**REPORT TO:** Committee of Adjustment

**REPORT NO.:** DSD-2025-211

**SUBJECT:** Minor Variance Application A2025-043 – 82 Brunswick Avenue  
(Future Retained Parcel)  
Minor Variance Application A2025-044 – 82 Brunswick Avenue  
(Future Severed Parcel / 84 Brunswick Avenue)

**Figure 4: Rear Yard Setback Measurements**

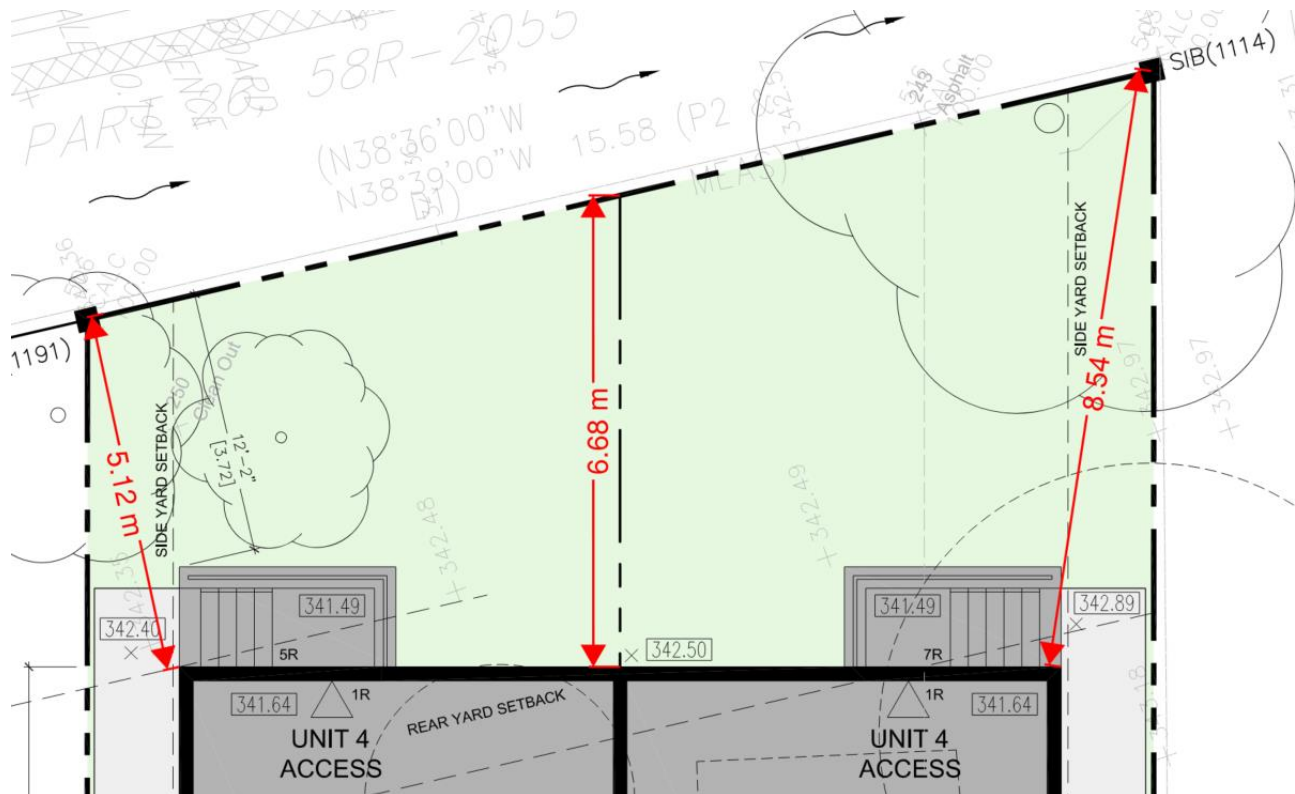
The intent of the rear yard setback is to ensure both sufficient distance from lot lines to ensure privacy to abutting properties, and to provide private, outdoor amenity space to the lot. The need for reductions to the rear yard setbacks are due to the angle of the rear lot line. For the future severed lot, the setback is 5.1 metres at its shortest point, which continues to increase until reaching 6.6 metres at its longest. The average rear yard setback is roughly 5.8 metres, which results in a rear yard area of approximately 43 square metres. The minimum rear yard size as calculated by the required zone provisions is 56.25 square metres (7.5 metres x 7.5 metres). The 43 square metres that would be provided is 76% the area of the typical requirement. Based on the intent of the rear yard

setback, the reduction results in an area that does not provide appropriate outdoor amenity area for a primary dwelling and three ADU's.

For the future retained lot, the setback is 6.6 metres at its shortest point, which continues to increase until reaching 8.5 metres at its longest. The average rear yard setback is roughly 7.6 metres, which is above the minimum requirement of 7.5 metres. For this lot, the reduction to the rear yard effectively meets the intent of the Zoning By-law.

As noted in the above analysis regarding the intent of the Zoning By-law, the future retained parcel and 6.6 metre rear yard setback is generally technical in nature due to the angled rear lot line and would be considered minor.
